**Addendum No. 2
City of Corbin, Kentucky
Corbin Center Addition Project
Bid Date: June 3, 2025
Addendum Issue Date: May 28, 2025**

**Corbin Center
MSE of Kentucky, Inc.**

A-1

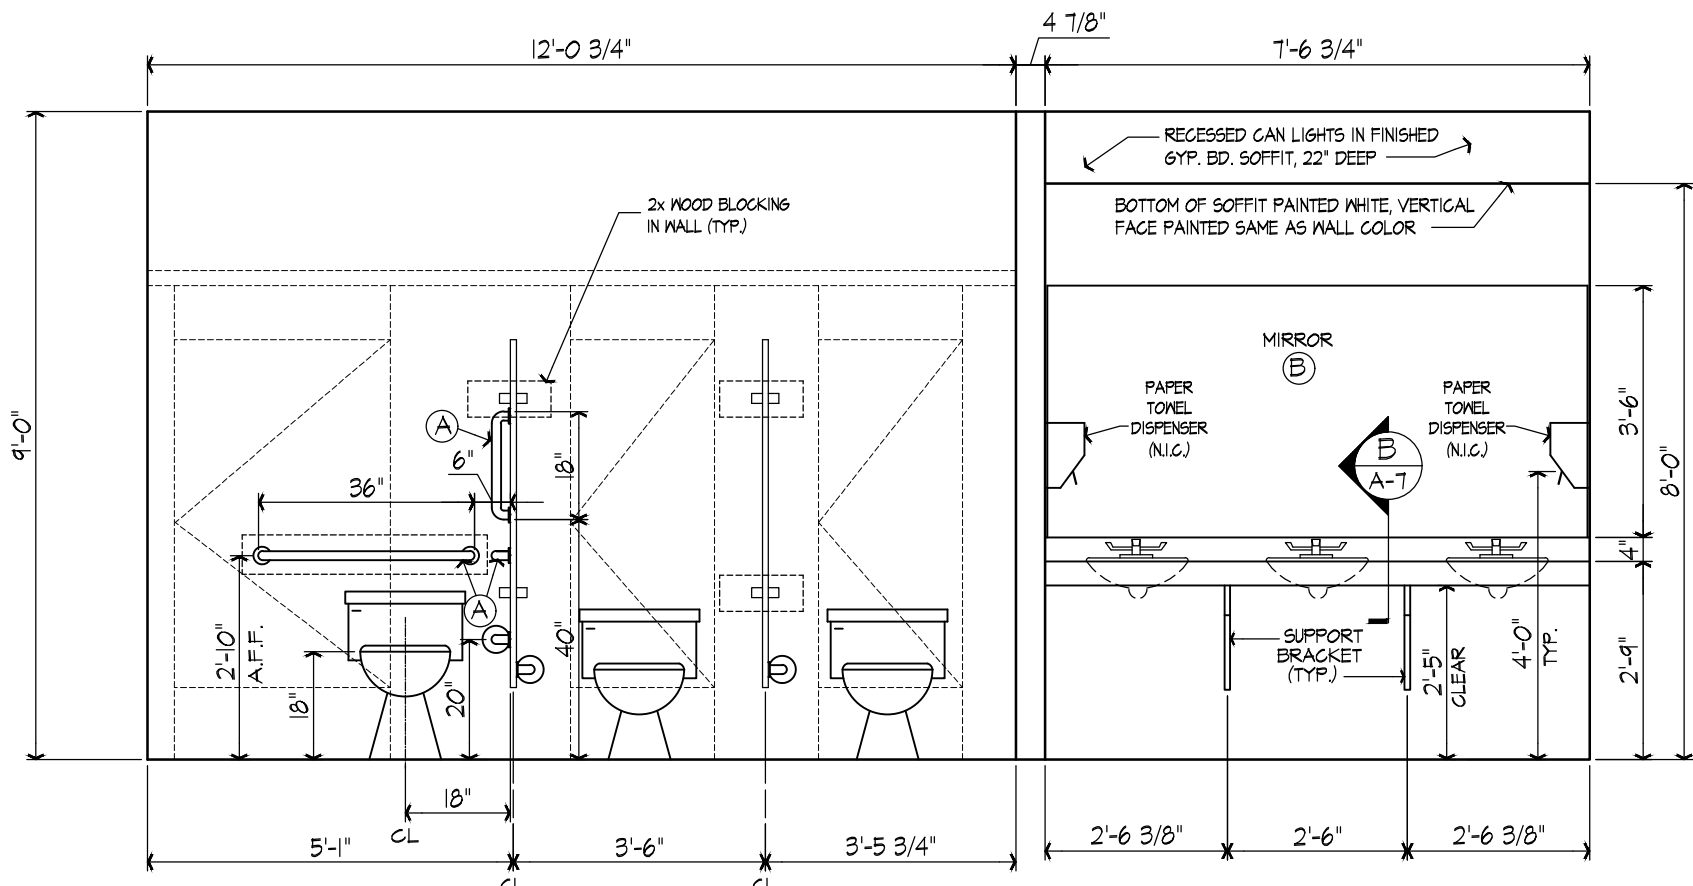
- Item 1:** Replace Spec Section 10650 Operable Partitions with attached revised Section 10650 Operable Partitions.
- Item 2:** Replace Plan Sheet A1 – Floor Plan with attached Plan Sheet A1 – Floor Plan. Revised floor plan A-1 showing changes to walls around the folding partition is included in the addenda.
- Item 3:** Revised interior elevations A-7 showing revisions to lobby cabinetry, detail 6/A-7 and A/A-7 is included in the addenda.
- Item 4:** Door #24 is 7'-0" height, not 4'-0".
- Item 5:** Replace Plan Sheet U-1 – Site Utility Plan with attached Plan Sheet U-1 – Site Utility Plan.

A-7

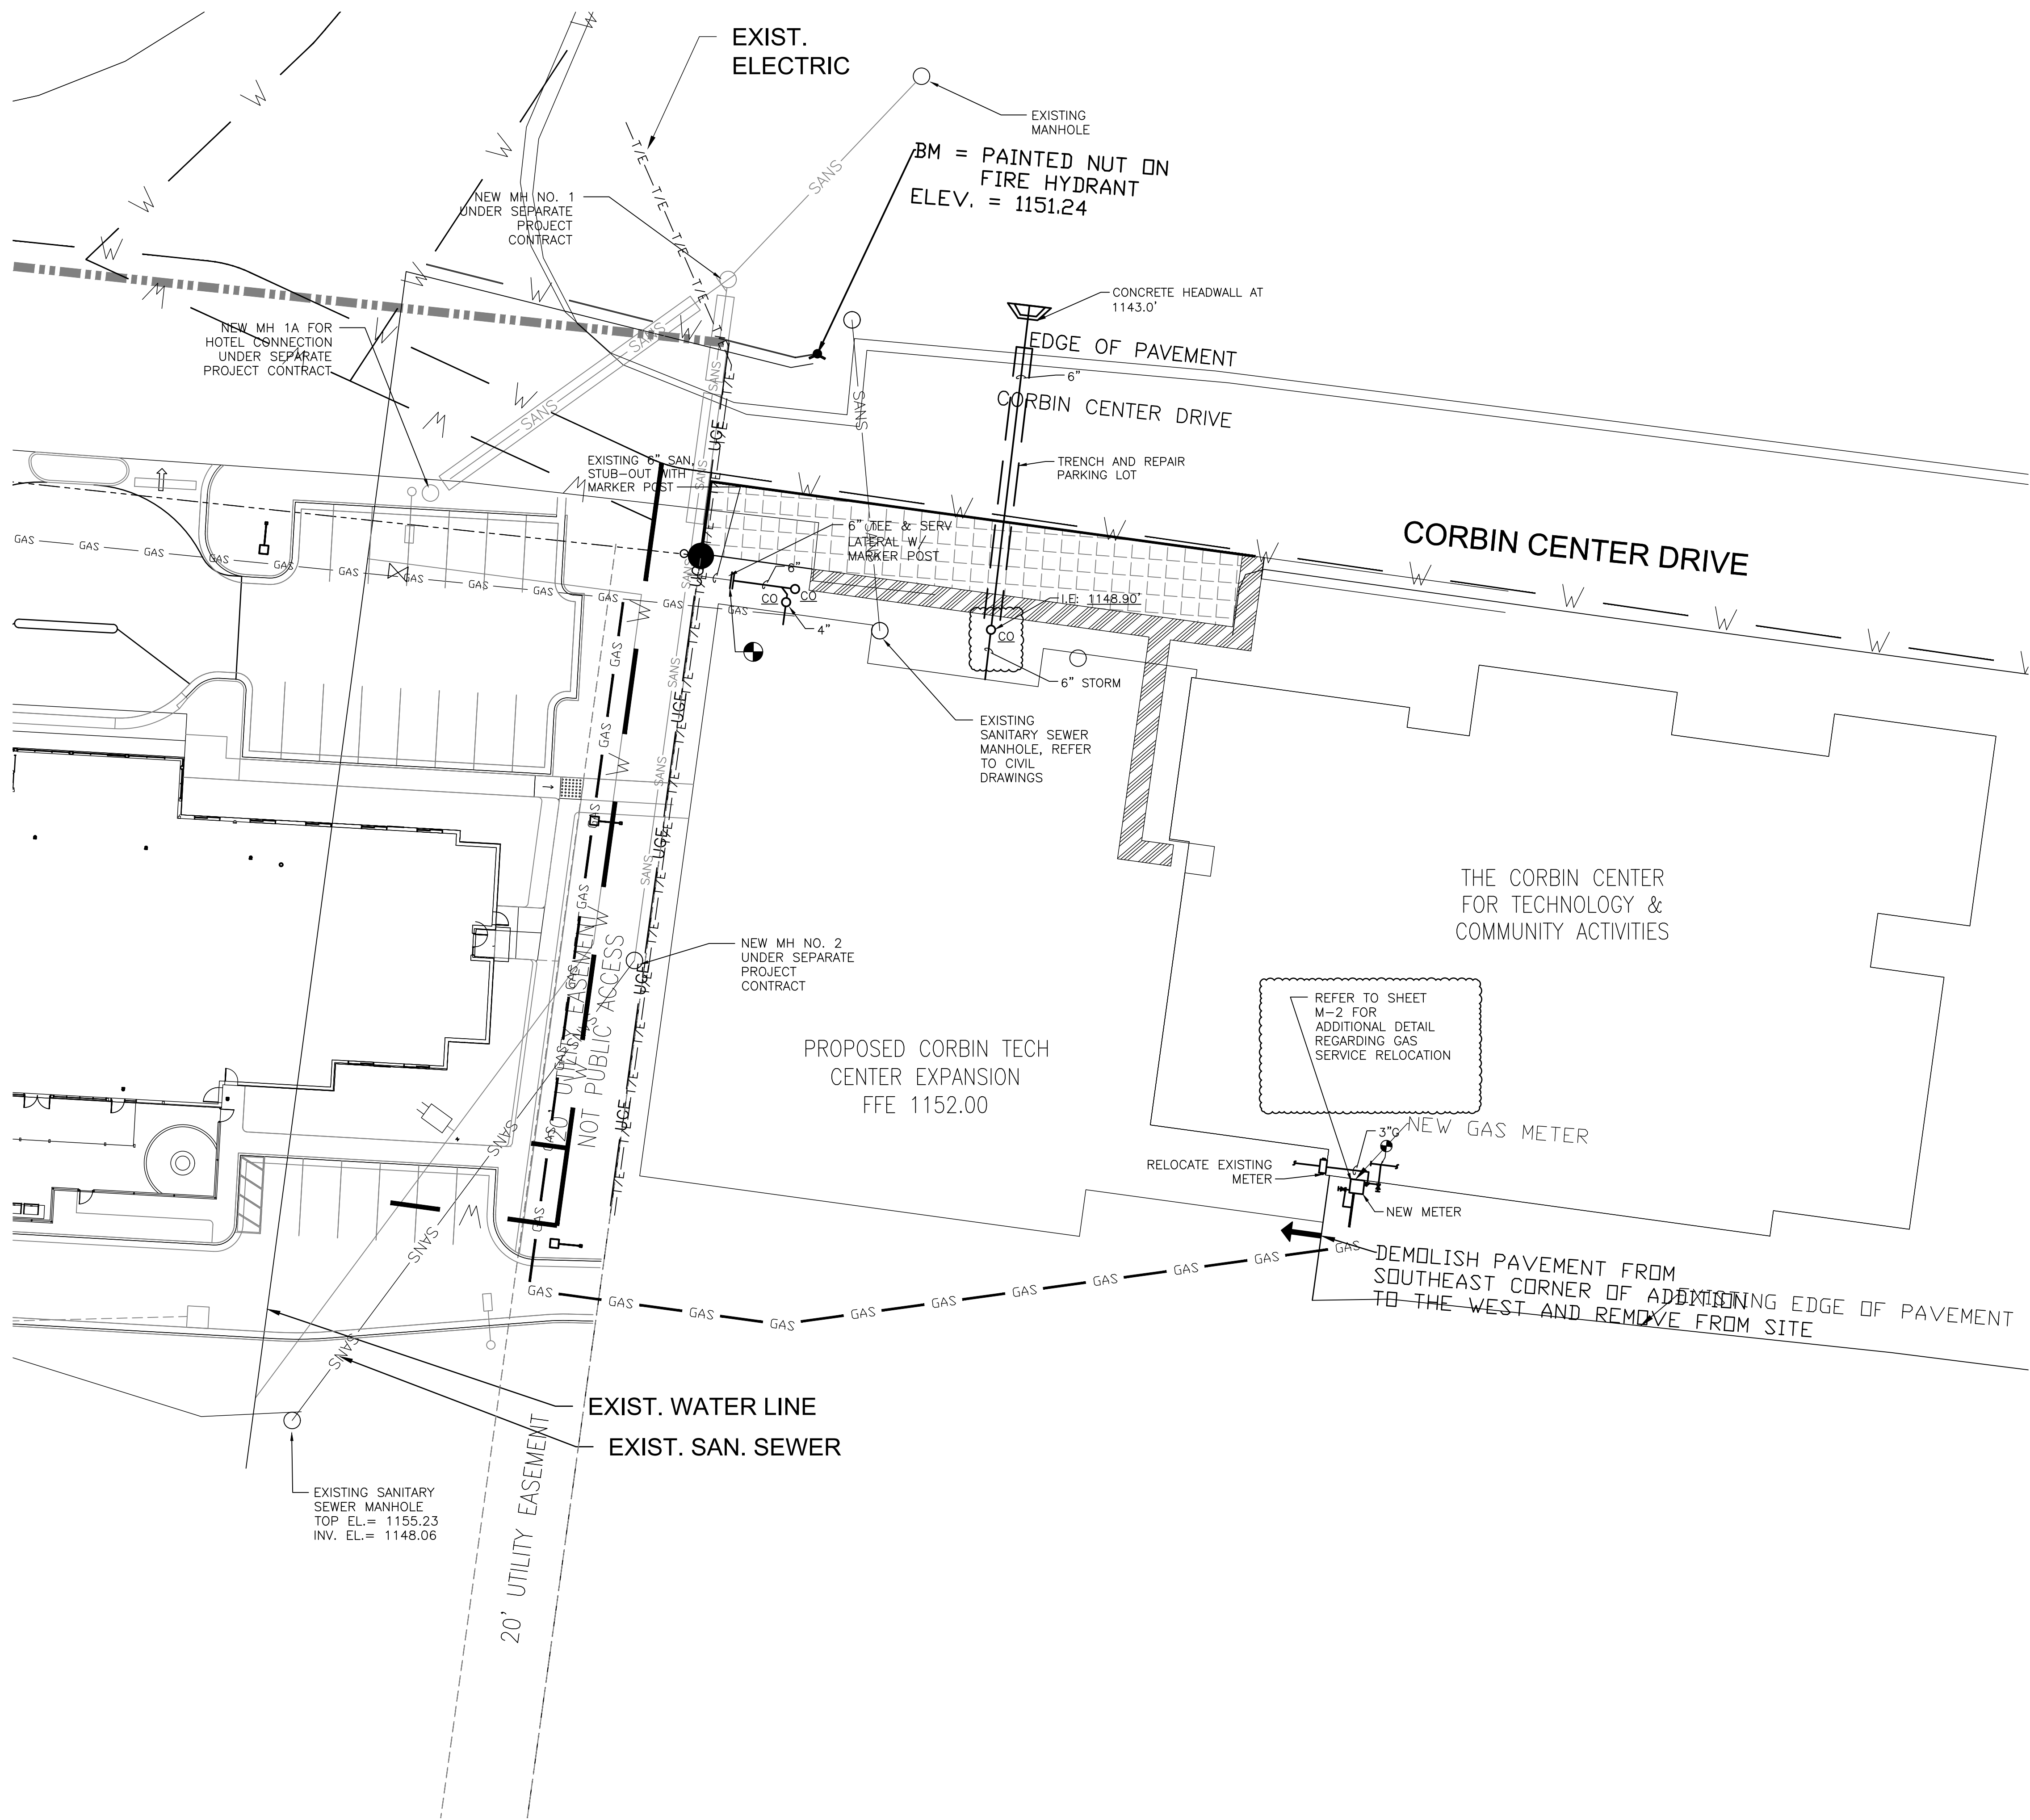
11. The Finish Schedule indicates Storage Room 115 shows an M-1 type Vinyl Chair Rail, but the Finish Specifications do not have an M-1 listed. Please clarify what is to be used here. **Answer: Disregard the M-1 notation. There is no chair rail in Room 115.**
